The Office of Utility Consumer Counselor's Comments Regarding Vectren Integrated Resource Plan

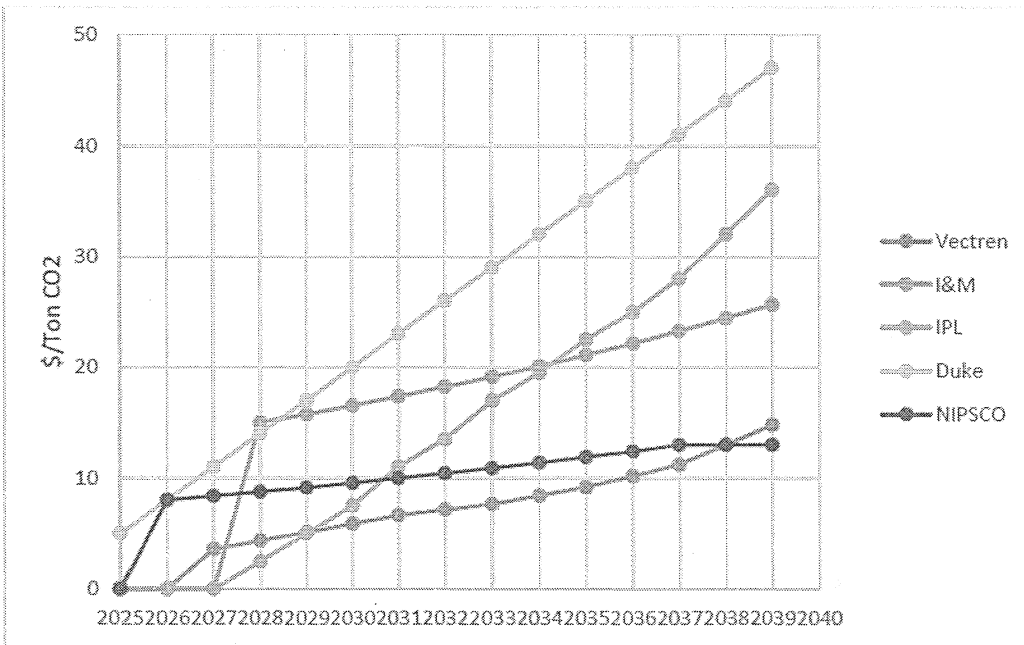
In calculating an avoided T&D avoided capacity cost, Vectren employs a "rule of thumb" of 10% of the avoided generating capacity cost. There is no relationship between reductions in demands on the T&D system and decreased demands caused by DSM activity. Presently, none of Indiana's investor-owned utilities (IOUs) approach this topic in a consistent manner. The avoided T&D costs utilities apply varies significantly and influences the amounts of Energy Efficiency resources selected. The OUCC offers the following method to quantify T&D capacity avoided costs:

- a. Identify distribution circuits requiring capacity improvements;
- b. Exclude projects addressed through Transmission, Distribution, and Storage System Improvement Charges (TDSIC) programs;

- c. Determine which situations are caused by load growth due to new customers (such as new subdivisions, shopping centers or other commercial expansion) and exclude those circuits from the analysis. These are not distribution capacity issues that can be alleviated through DSM;

- d. For the remaining circuits, estimate the portion of the project costs including only those components related to improving capacity. The concept of quantifying only those costs relating to capacity have been applied in other jurisdictions;¹ and

- e. Multiply the percentage of demand reduction based upon DSM compared to the Vectren system load by the annualized cost per kW-year of capacity improvements determined in (d) above.
